ROBOKIT

RE-DESIGN BY GROUP 6

**ORIGINAL****ALTERED****BASE**

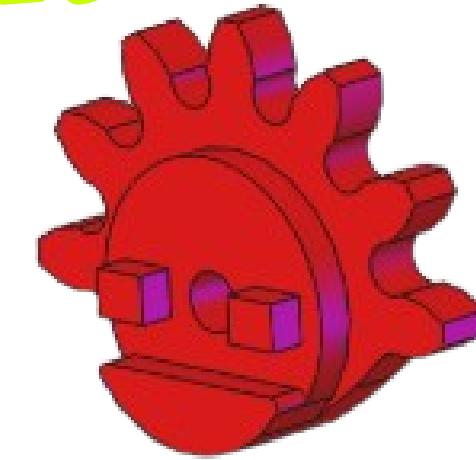
The height of the base has been increased to provide better overall stability, and additional structural supports have been integrated into the baseplate to enhance its strength and ensure improved load-bearing capacity.

## Gripper Part 1

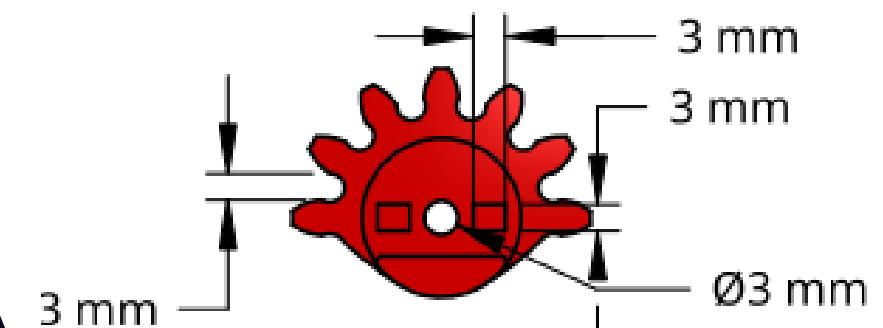
- The altered version could be optimized for aesthetics, better fit, or improved functionality.
- The base platform may provide more stability or ease of assembly.
- Adjusting the hole shape might help with better alignment or reduced friction during use.

## Gripper Part 2

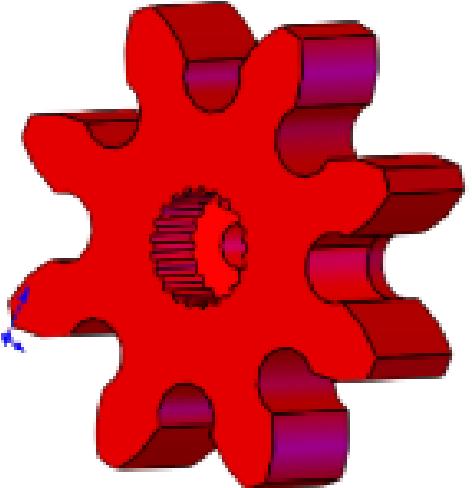
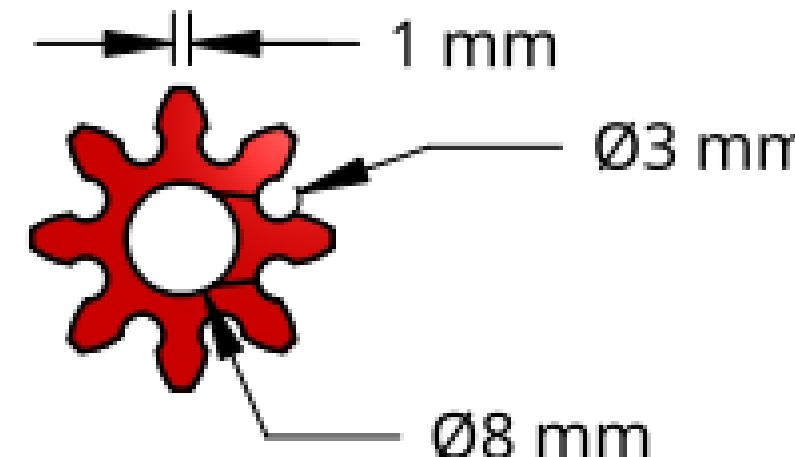
The central diameter of the gear has been reduced to minimize weight and compact the design, while additional teeth have been incorporated around its perimeter to enhance grip and improve mechanical engagement and support during operation.

## Gripper Part 3

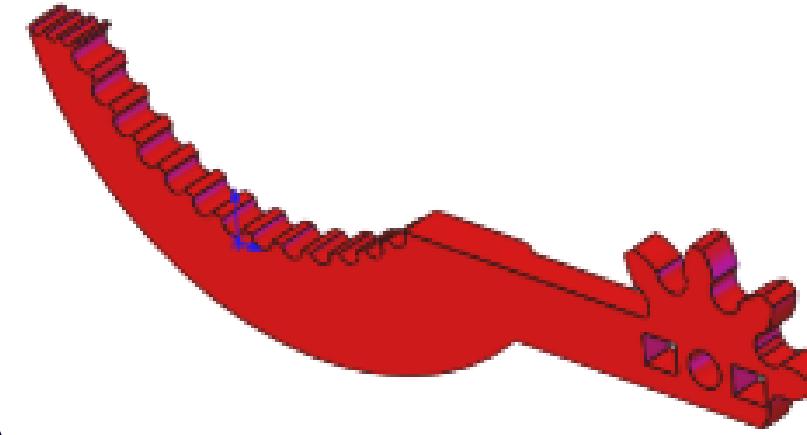
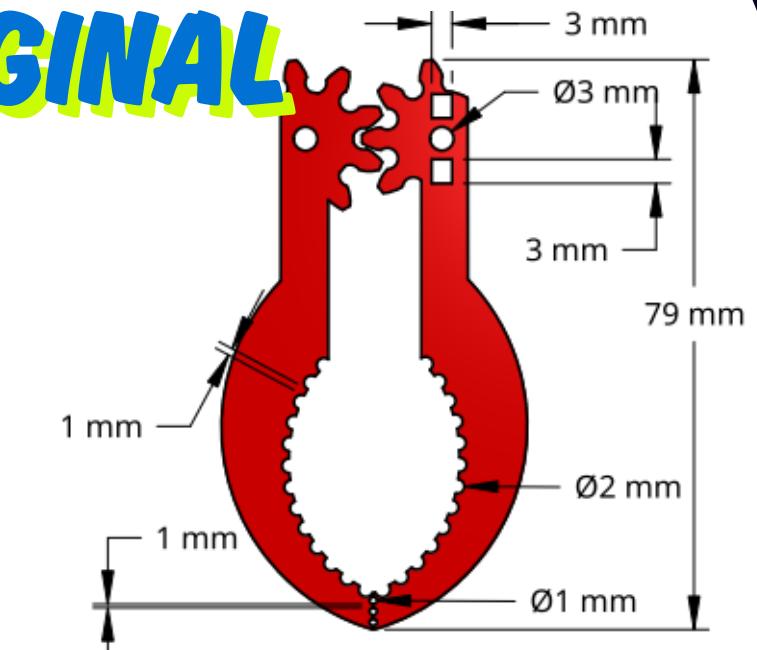
- The curved design in the altered version seems to improve functionality in rotational or grabbing tasks, possibly allowing for:
- Better angular reach
- Smoother engagement with circular or irregular objects
- The altered design could also enhance aesthetics or mechanical efficiency.

## Gripper Part 4

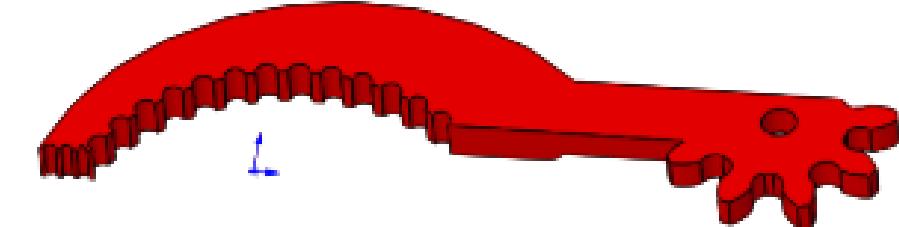
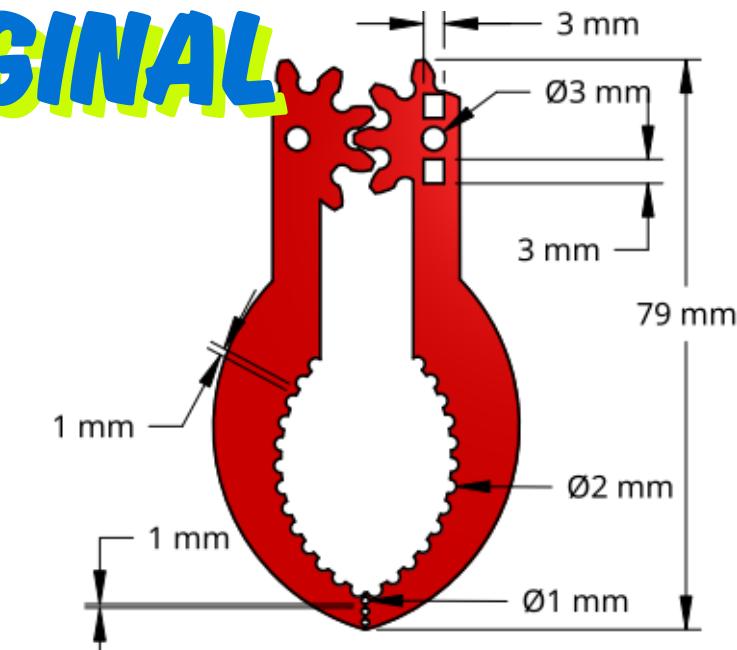
- Simplification: fewer parts, easier to print or assemble.
- Improved range of motion: smoother and wider arc when rotating.
- Function shift: from gripping to maybe sweeping, rotating, or guiding.

The transition from a dual-arm gripper to a single curved component signals a functional shift—perhaps for use in a rotating arm, rack-and-pinion setup, or claw-like application.

## Gripper Part 5

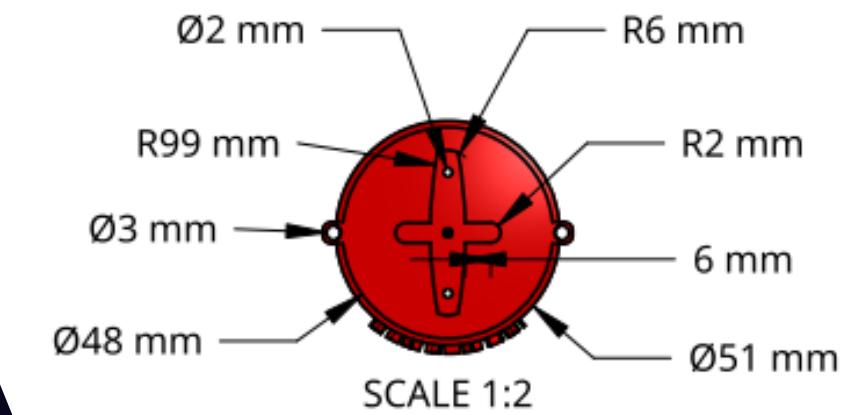
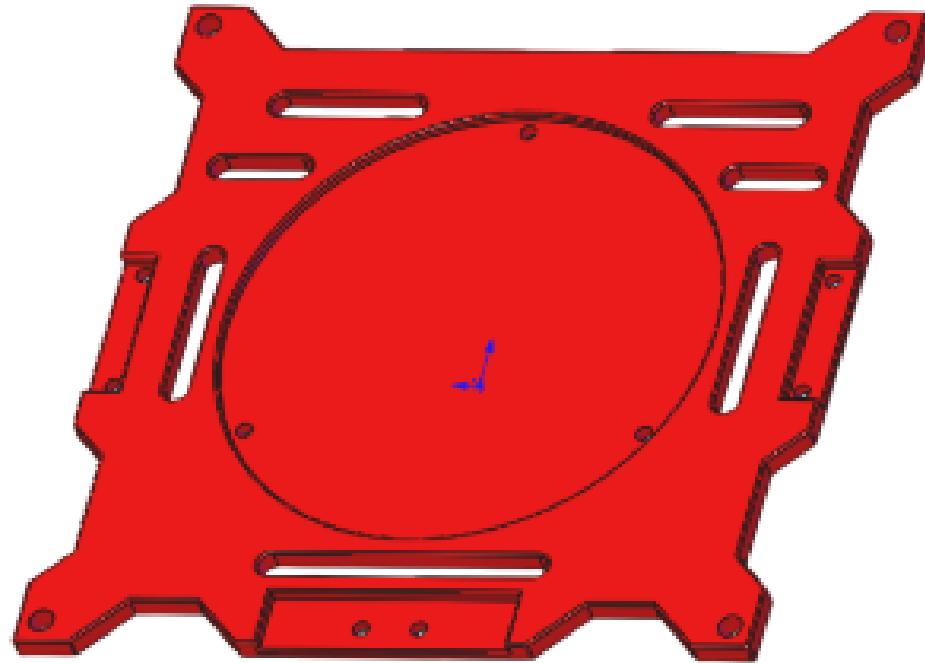
- Handle Added: The altered design has a rectangular handle on top that the original doesn't have.
- Text Engraved: The altered version includes some text on the side.
- Slight Shape Changes: The altered one looks a bit more refined or cleaned up.

# SENSOR PLATE

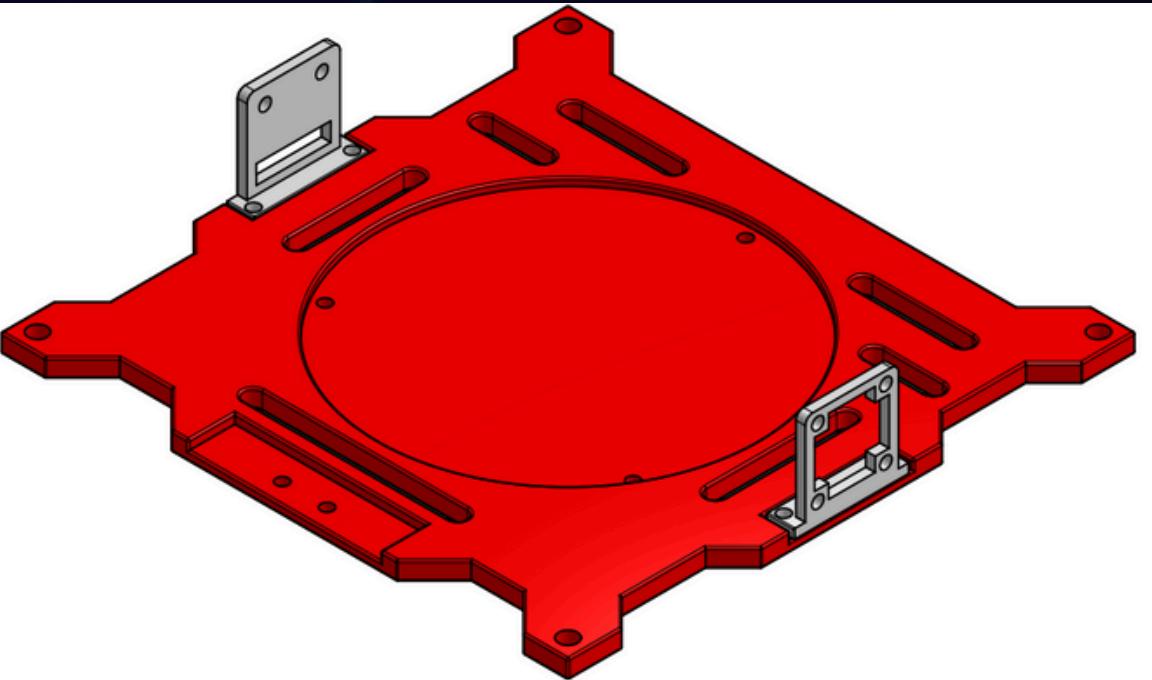
- Cutouts Changed: The slots and cutouts around the edges have been slightly changed in shape and position in the altered design.
- Cleaner Look: The altered version looks simpler and more uniform, possibly for easier manufacturing or a different mounting method.

LID

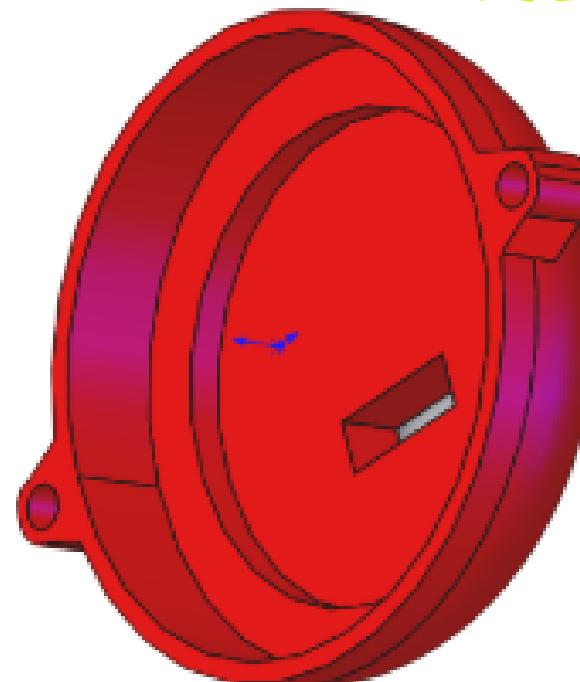
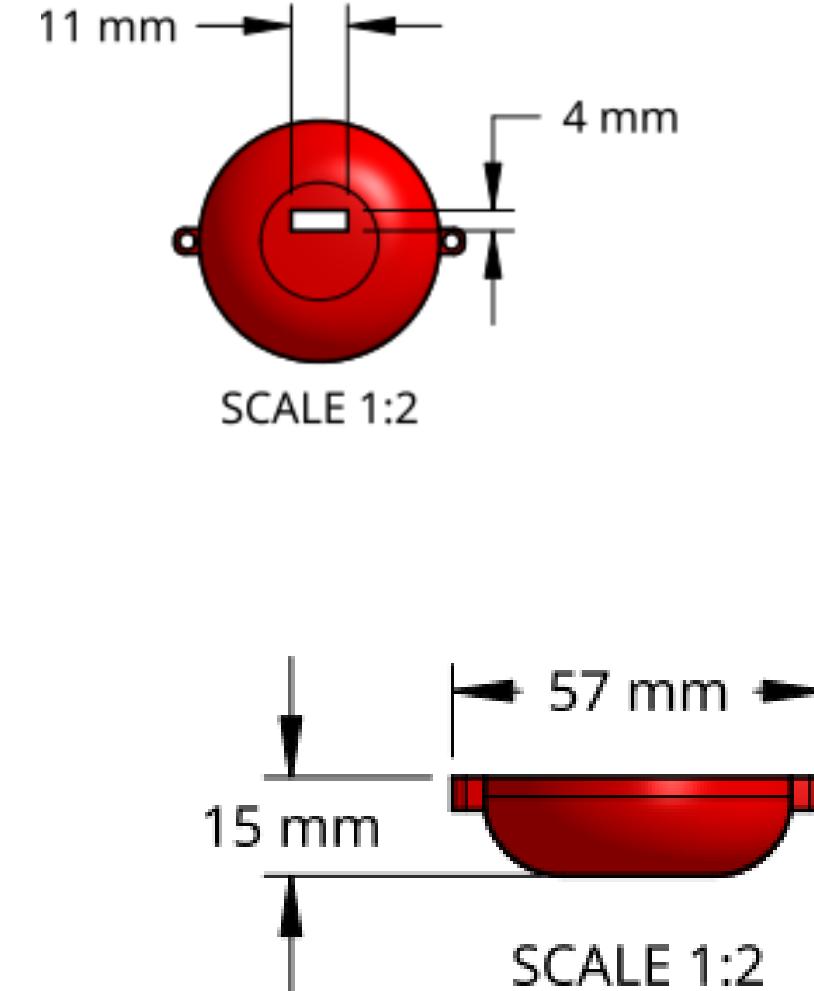
The section surrounding the screw hole has been reinforced with increased thickness to provide additional structural support, ensuring greater durability and resistance to stress during assembly and usage.

## Connector 2

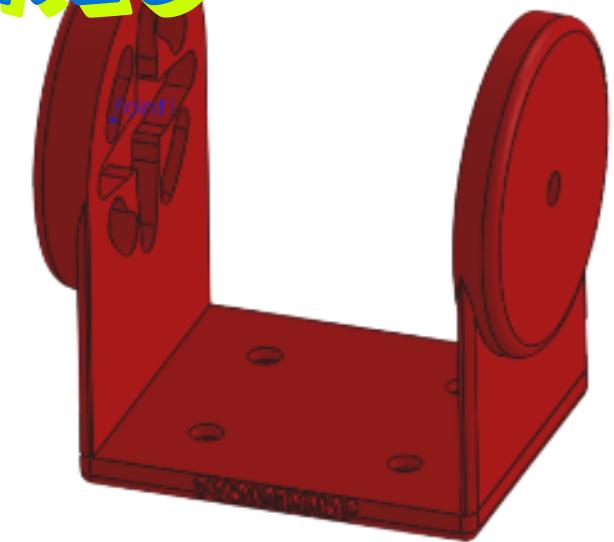
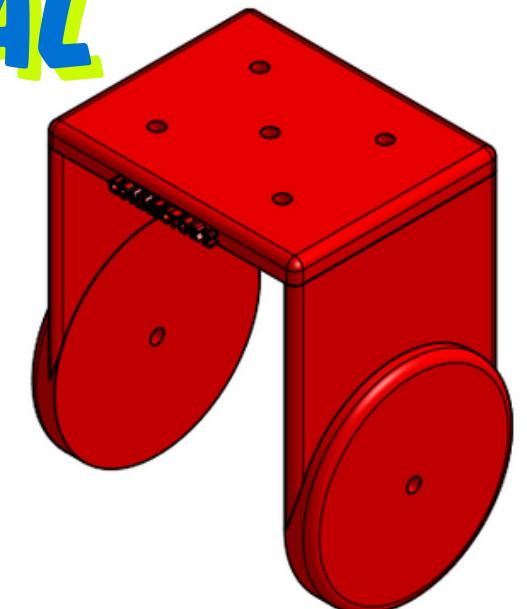
Additional holes have been added to the design, reinforcing the existing ones to further improve stability and ensure a more secure connection during the motor's operation.

## Connector 3

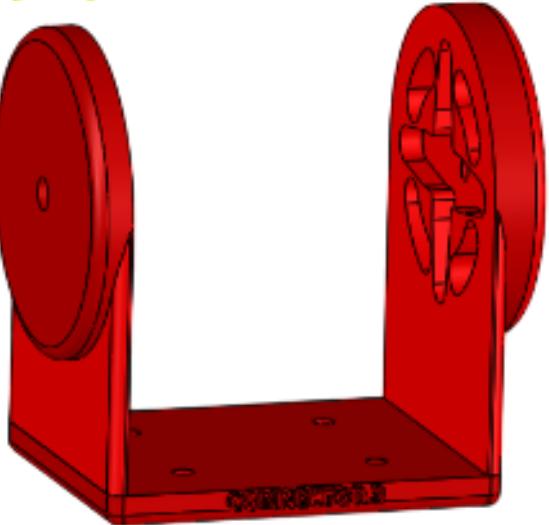
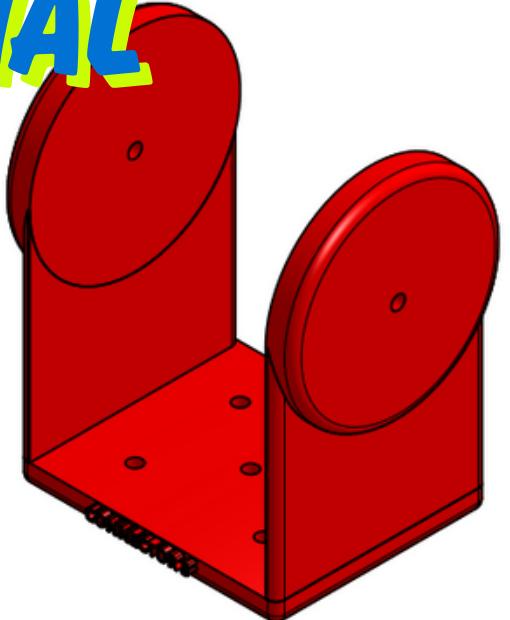
(Similar to Connector 2) Additional holes have been added to the design, reinforcing the existing ones to further improve stability and ensure a more secure connection during the motor's operation.

# MODULAR

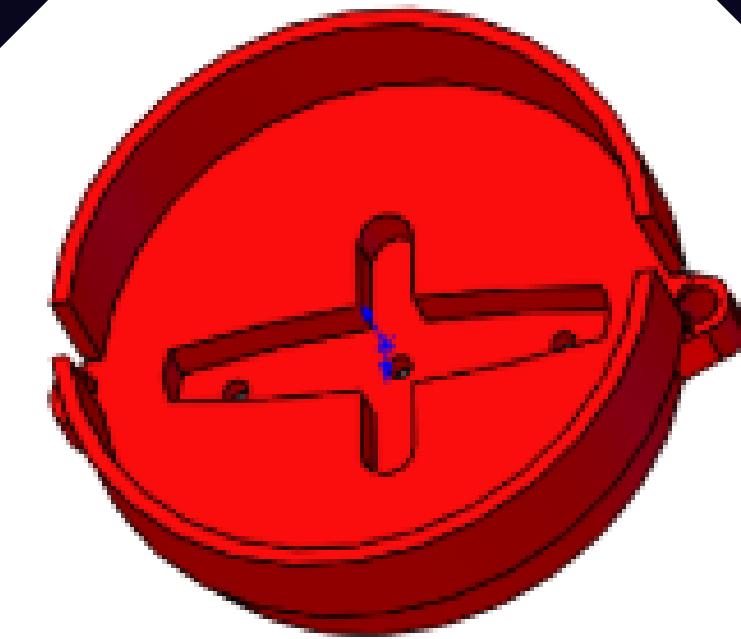
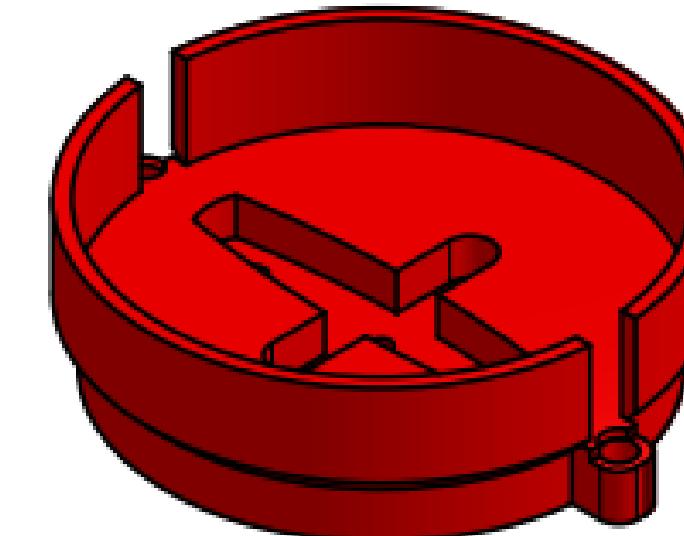
The screw holes have been thickened to reinforce the structure, improving durability and preventing breakage during assembly.

# BASEPLATE ALTERATE

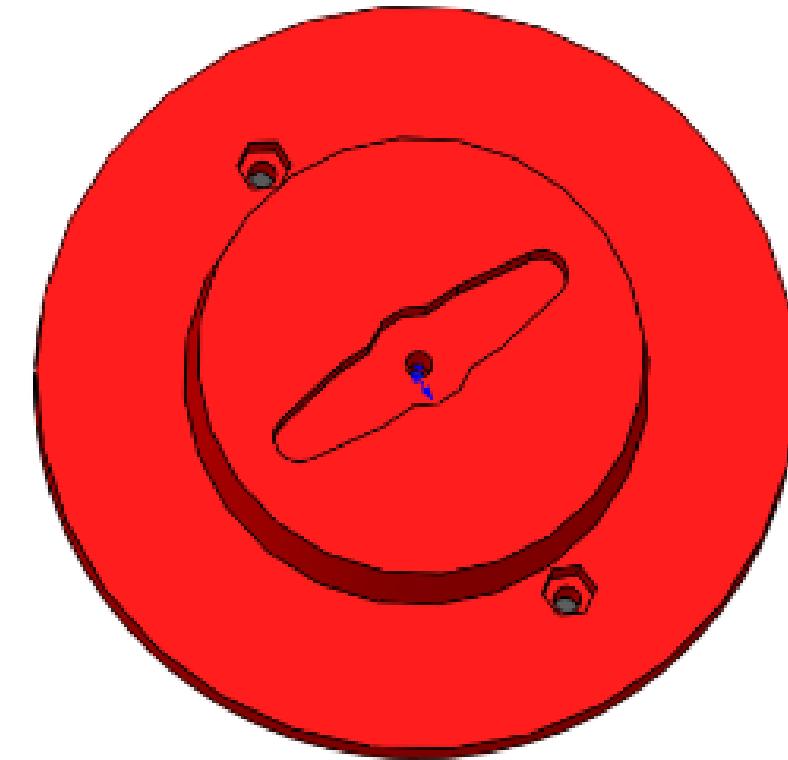
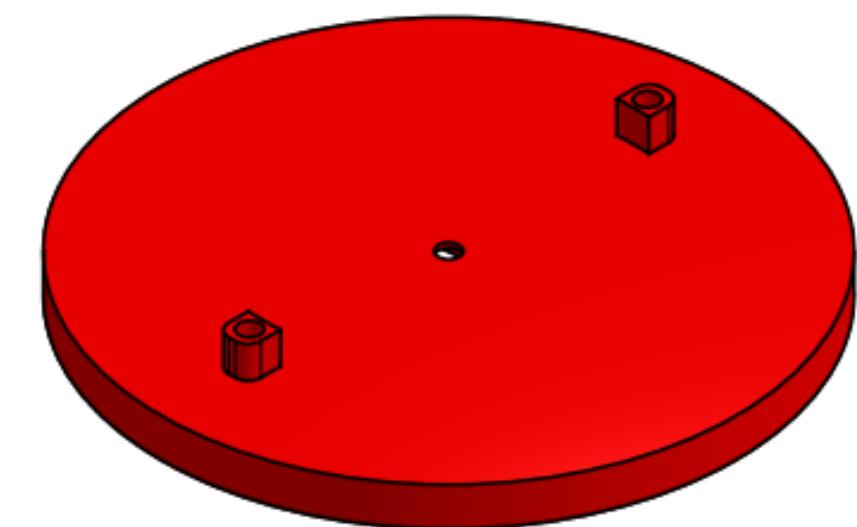
A “keyhole” has been added to enhance stability, preventing movement and ensuring a more secure connection when the motor is in motion.

## Joint 2

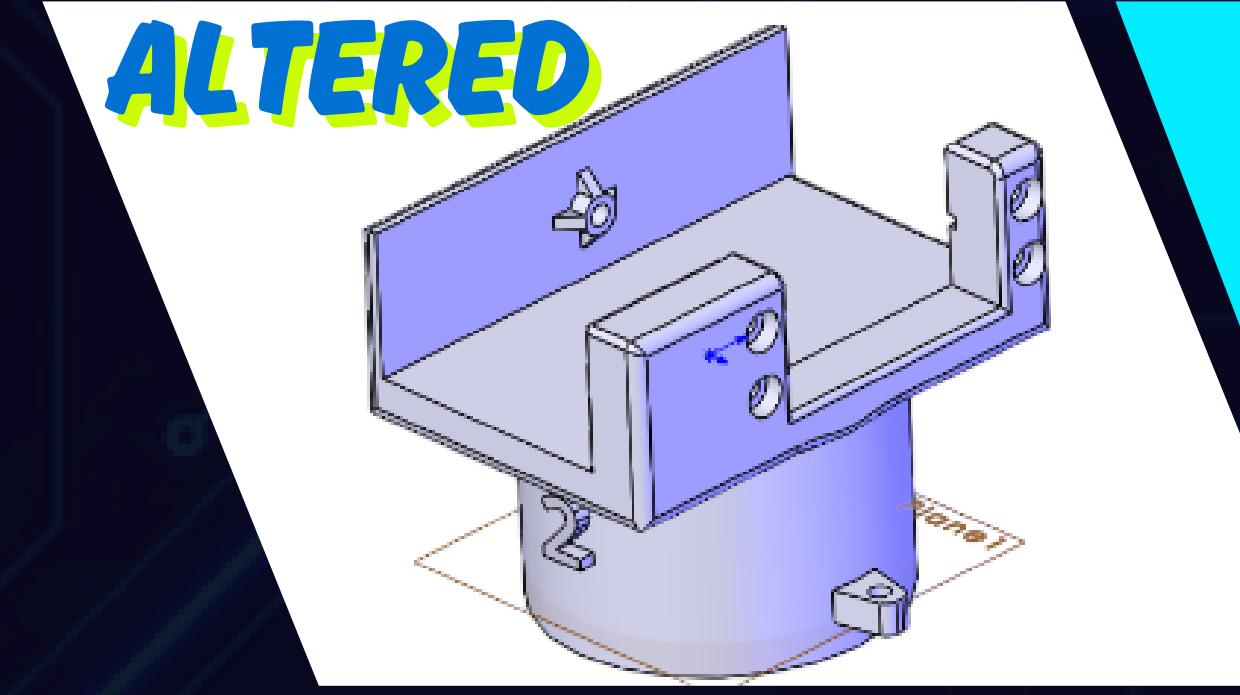
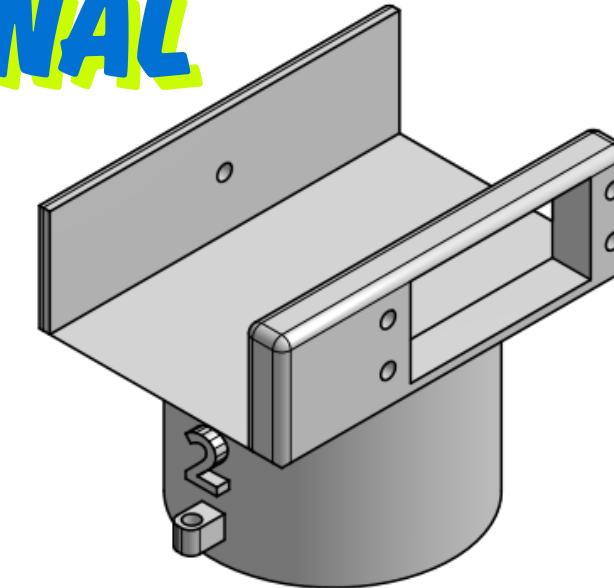
The screw holes has been repositioned to the side, and the upper frame for the motor has been removed to allow for better access and stability. Additional support has been added to the screw hole for the connected joint, and the hole has been deepened to ensure the screw doesn't stick out, providing a cleaner and more secure assembly.
